RE: OUTLOOK AT NINE MILE DRAINAGE REVIEW

We have reviewed the Outlook at Nine Mile submittal received on February 10, 2020. The submittal included a Phase III Drainage Report for Outlook Nine Mile, Construction Plans for Outlook at Nine Mile, and a Site Plan for Outlook at Nine Mile all revised January 27, 2020, by Harris Kocher Smith. The resubmittal also included a response to comments letter from Norris Design, dated January 31, 2020. We have the following comments to offer:

Subject: Nine Mile Corner - Site Plan SP-000832-2016

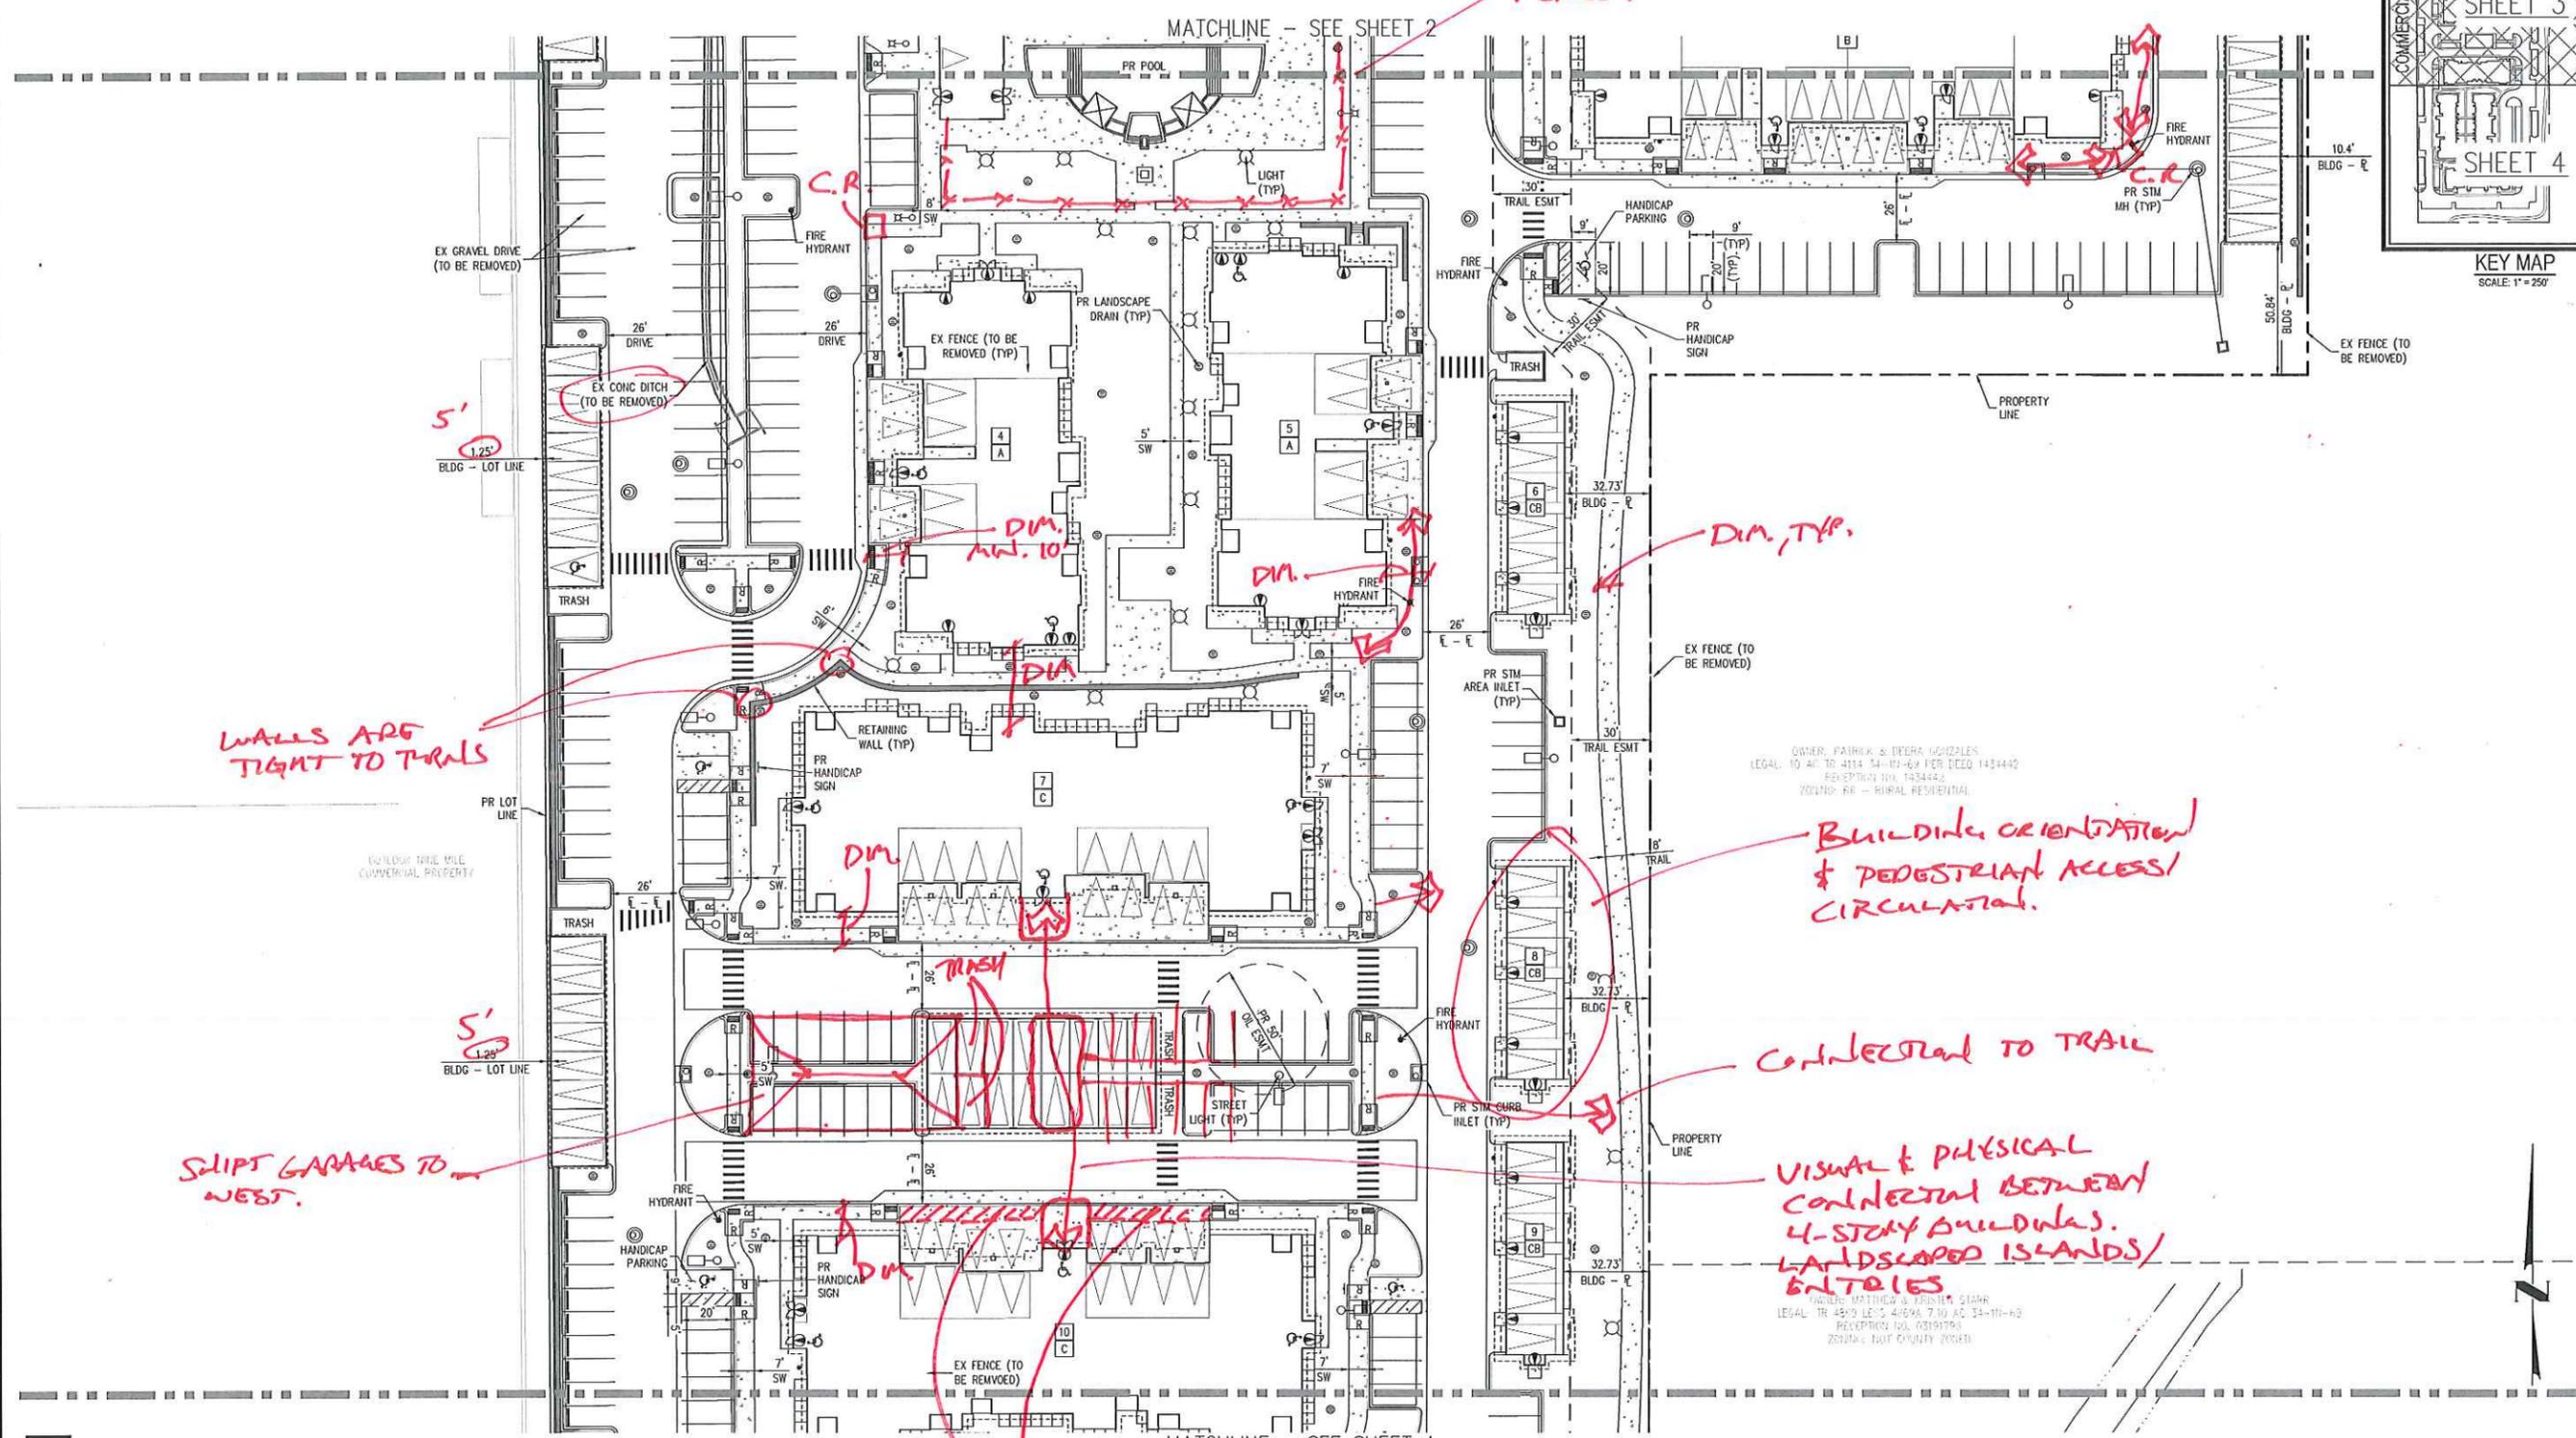
WALLS ARE TIGHT TO TRAILS

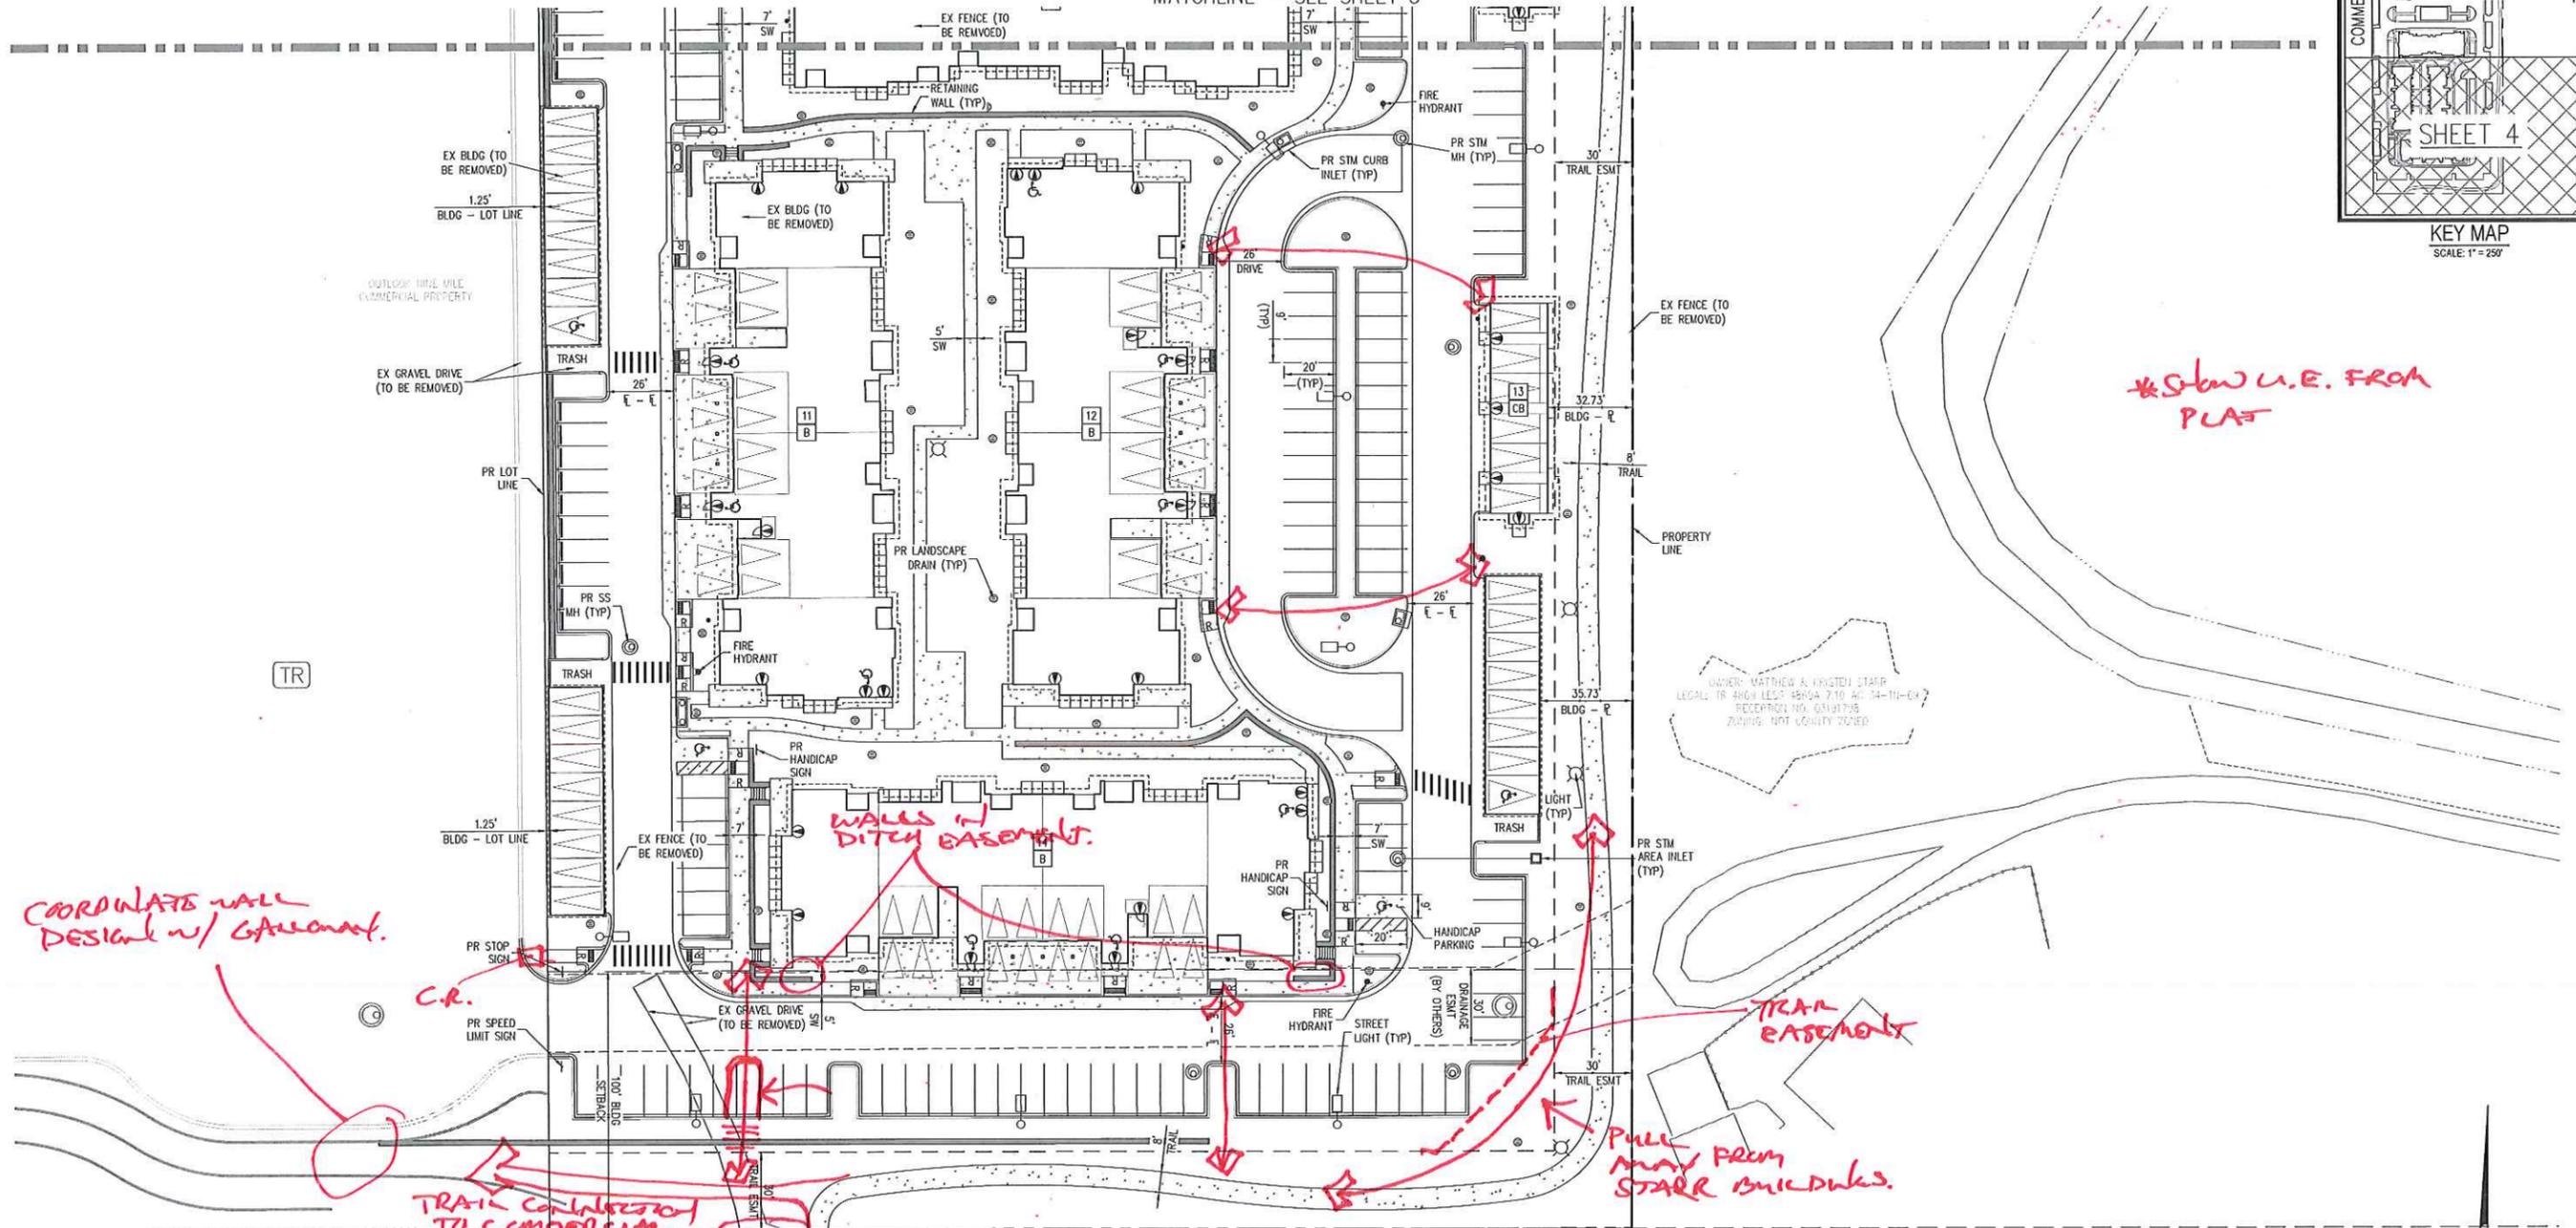
COORDINATE WALL DESIGN w/ CONTRACTOR.

WALLS w/ DITCH EASEMENT.

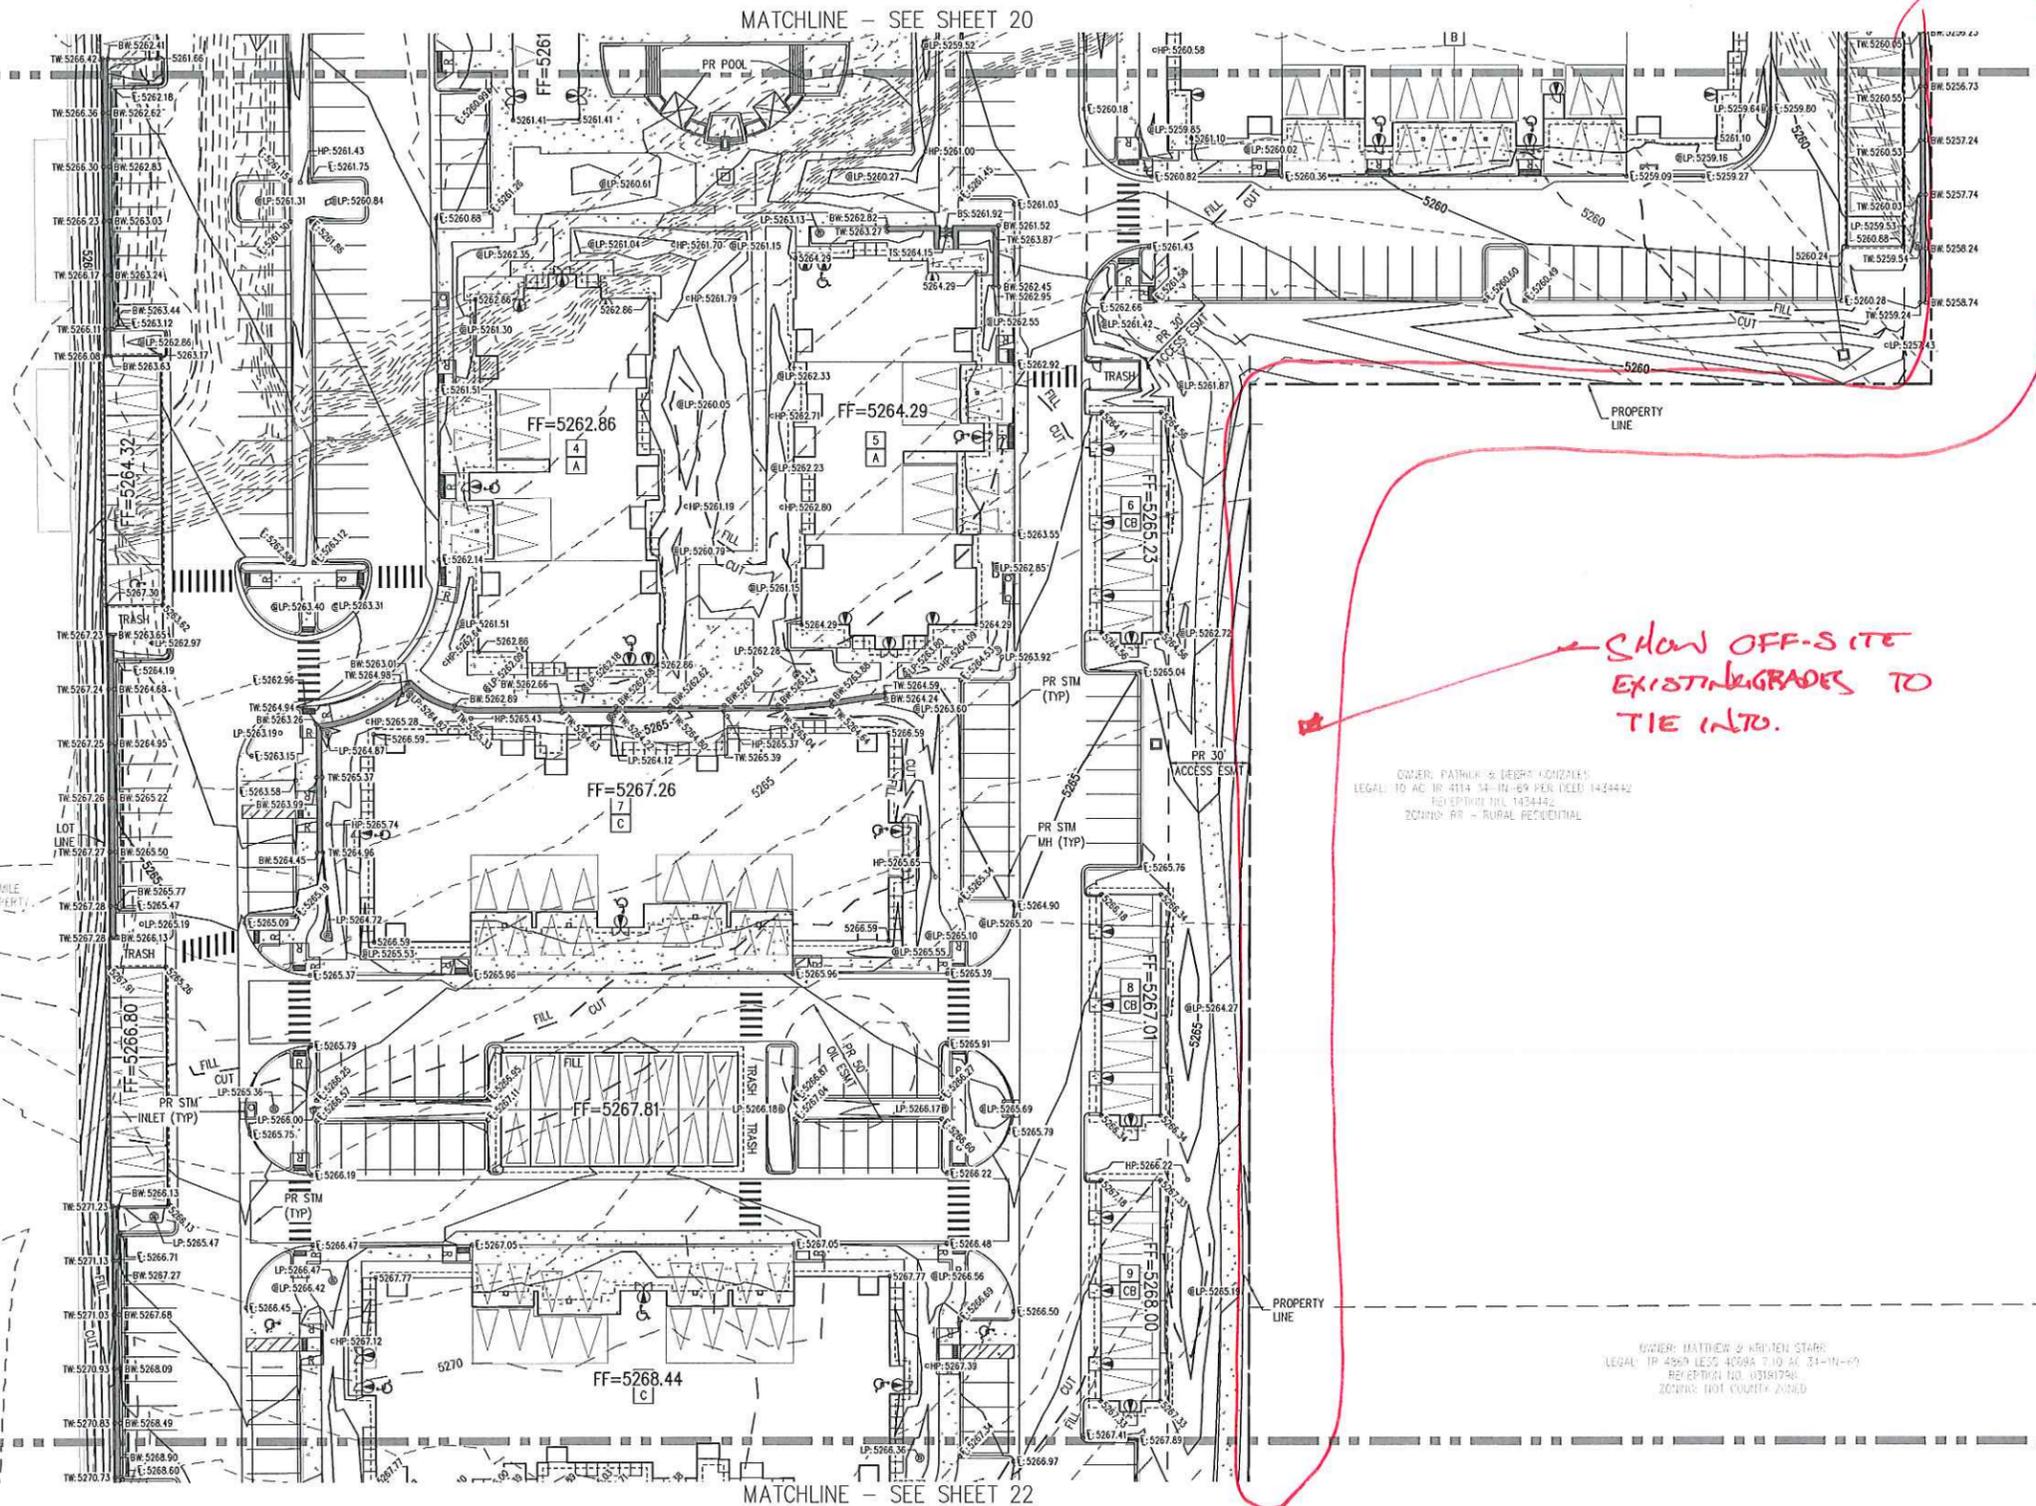
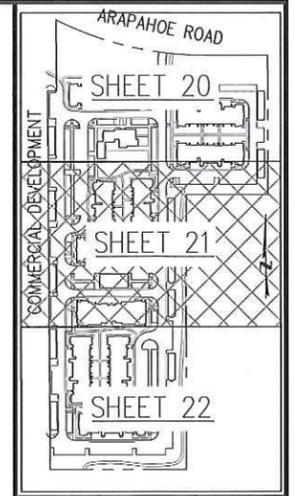
SHOW OFF-SITE
EXISTING GRADES TO
TIE INTO.
